# Access Compliance Report

## Public Rights-of-Way

### (Curb Ramps)

Intersection ID: 7031	Main Street: BROOKSHIRE_BV	Cross Street: OAKDALE_RD	Location: NW
ADA ID: E652172549AB	Ramp Type: Perp	Initial Pass/Fail: Fail	Overall Compliance: No
			Severity Score: 21.25

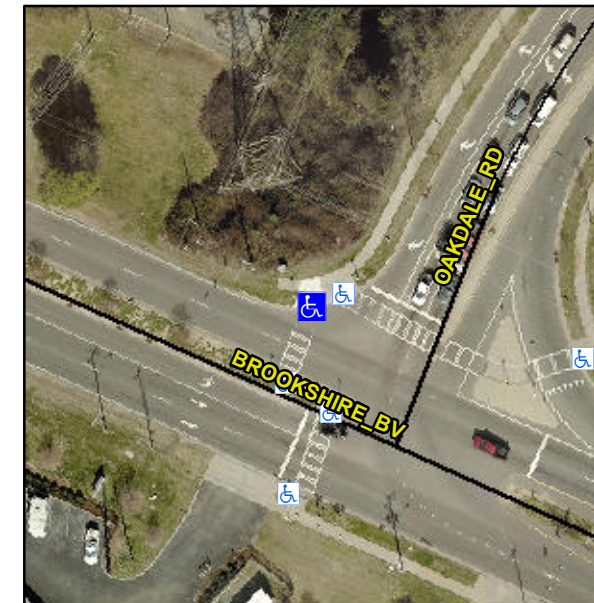
**Not Found, R304.5.1, R304.2.2**

Compliance	Description	Data	Compliance	Description	Data
N/A	Ramp Length (in)	95.0	No	Ramp Slope (%)	10.5
No	Ramp Width (in)	44.0	Yes	Ramp XSlope (%)	0.1
N/A	Flare Type LT	N/A	N/A	Flare Type RT	N/A
N/A	Flare Slope LT (%)	N/A	N/A	Flare Slope RT (%)	N/A
N/A	Flare Traversable LT?	N/A	N/A	Flare Traversable RT?	N/A
N/A	Landing Length (in)	N/A	N/A	DWS Provided?	N/A
N/A	Landing Width (in)	N/A	N/A	DWS Contrast?	N/A
N/A	Landing Slope (%)	N/A	N/A	DWS Length (in)	N/A
N/A	Landing X Slope (%)	N/A	N/A	DWS Full Width?	N/A
N/A	Landing Curb? (Y/N)	N/A	N/A	DWS Offset (in)	N/A
N/A	Shared Landing?	N/A			
N/A	Gutter Ponding?	N/A	N/A	Gutter Slope (%)	N/A
N/A	Gutter Lip Ht (in)	N/A	N/A	Gutter X Slope (%)	N/A
N/A	Painted X Walk1?	Yes	N/A	Painted X Walk2?	N/A
	X Walk 1 Direction	To SW		X Walk 2 Direction	N/A
N/A	X Walk 1 Width (in)	112.0	N/A	X Walk 2 Width (in)	N/A
	X Walk 1 Slope (%)	0.6		X Walk 2 Slope (%)	N/A
	X Walk 1 X Slope (%)	1.7		X Walk 2 X Slope (%)	N/A

**Remove & Replace Entire Ramp.**
